CHANGE ORDER NUMBER: 12

Project: 1812-282

Roadway: Seward Junction

Change Order No. 12 Reason for Change

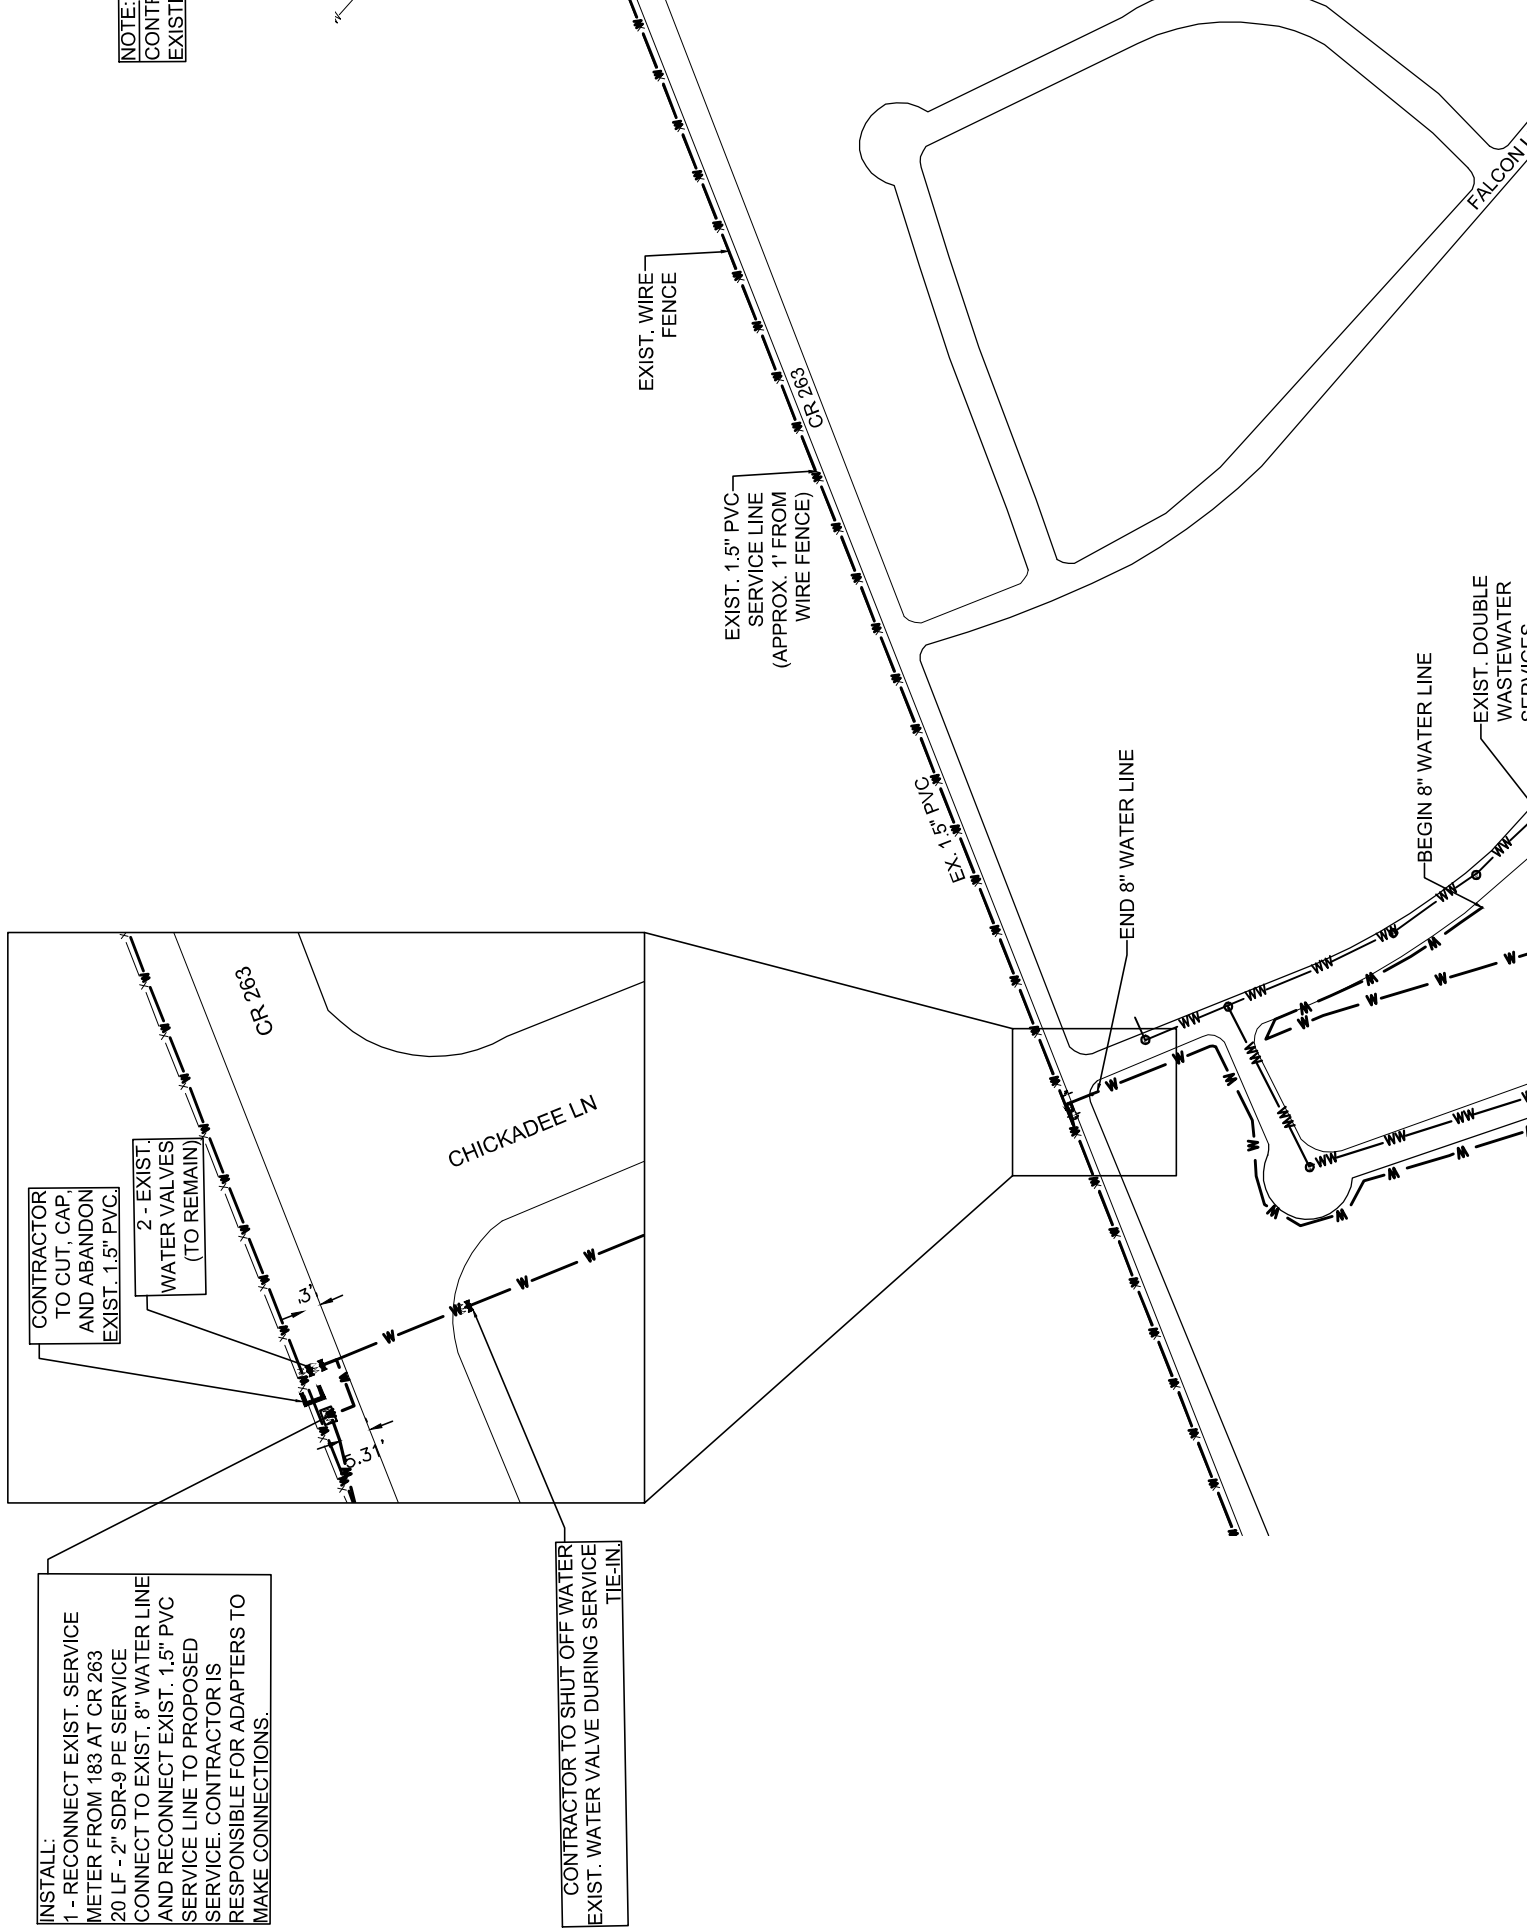
The following is the lump sum unit price for the additional work of relocating the Hogan water line service at CR 263 on the above referenced project.

INSTALL:
1 - RECONNECT EXIST. SERVICE
METER FROM 183 AT CR 263
20 LF - 2" SDR-9 PE SERVICE
CONNECT TO EXIST. 8" WATER LINE
AND RECONNECT EXIST. 1.5" PVC
SERVICE LINE TO PROPOSED
SERVICE. CONTRACTOR IS
RESPONSIBLE FOR ADAPTERS TO
MAKE CONNECTIONS.

CONTRACTOR TO SHUT OFF WATER
EXIST. WATER VALVE DURING SERVICE
TIE-IN.

CONTRACTOR
TO CUT, CAP,
AND ABANDON
EXIST. 1.5" PVC.
